## **SPRING GROVE SUBDIVISION, UNIT TWO**

APPLICATION NUMBER 22 DATE January 6, 2004

REQUEST Subdivision

# DETAIL SITE PLAN

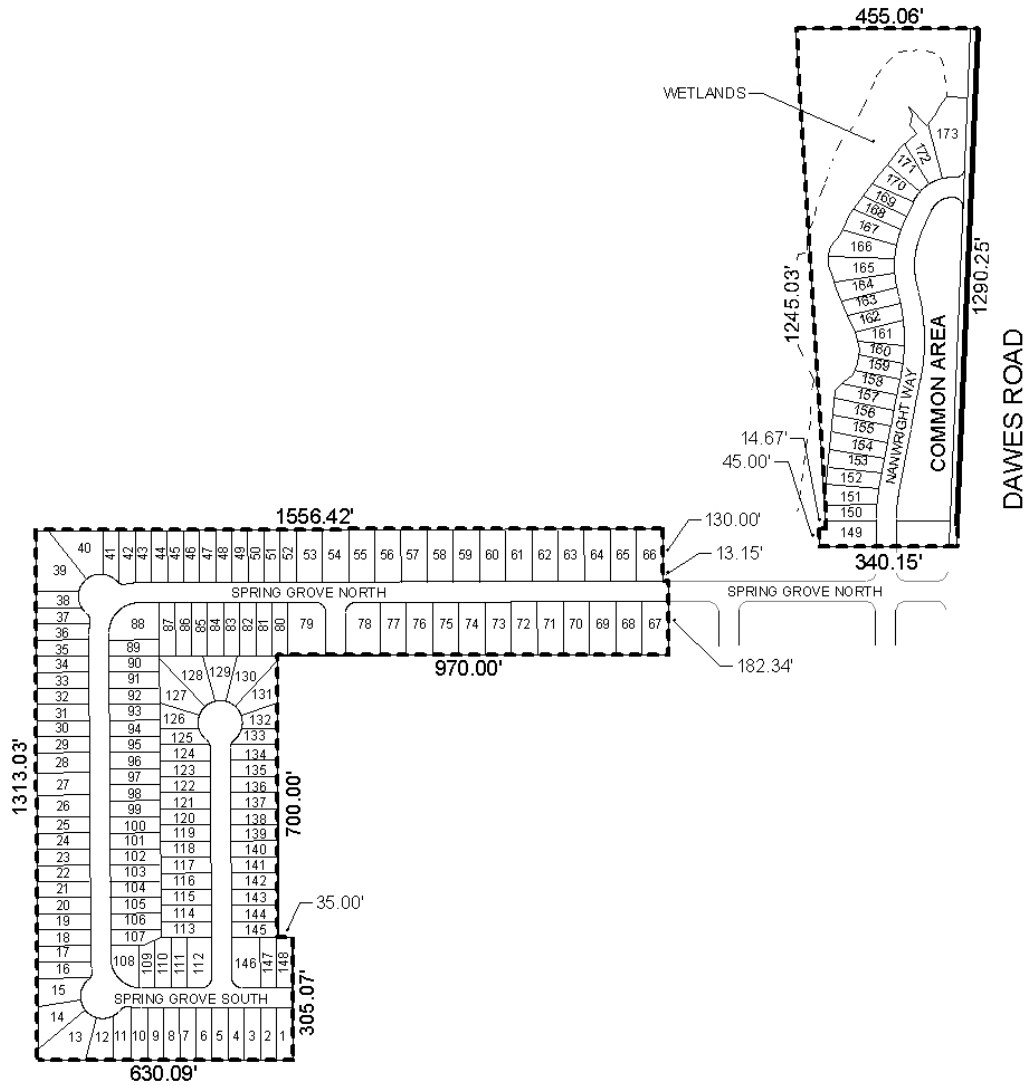
This unit will continue the style of Spring Grove Unit One with sidewalks, curb and gutter streets, and street lighting. As illustrated on the detail site plan, many lots are substandard in width and area; however, this development may be considered under the innovative development section of the Subdivision as a variety of housing options are offered on the site—patio/garden style homes, as well as standard single-family residences. However, a waiver of Section V.D.2. would be required for the substandard width and lot size.

The proposed layout creates a long "straight-a-way" and a traffic calming device (traffic circle) should be provided at the intersection of Lots 53-55, 78 and 79. While a street stub would typically be required to the North, as illustrated on the Vicinity Map, all the lots to the North are developed and have frontage on Jeff Hamilton Road. However, the lots to the west are land-locked, and one street stub should be provided in the area of Lots 26-28.

With a waiver of Section V.D.2. the plat will meet the minimum requirements of the Subdivision Regulations and is recommended for Tentative Approval subject to the following conditions: 1) the dedication of the necessary right-of-way to provide 50-feet from the centerline of Dawes Road, as shown on the plat submitted; 2) the provision of traffic calming (to be coordinated with and approved by County Engineering) at the intersections of Lots 53-55 and 78 and 79; 3) provision of a street stub to the West in the area of Lots 26 and 28; and 4) the approval of all applicable federal, state and local agencies prior to the recording of the final plat.
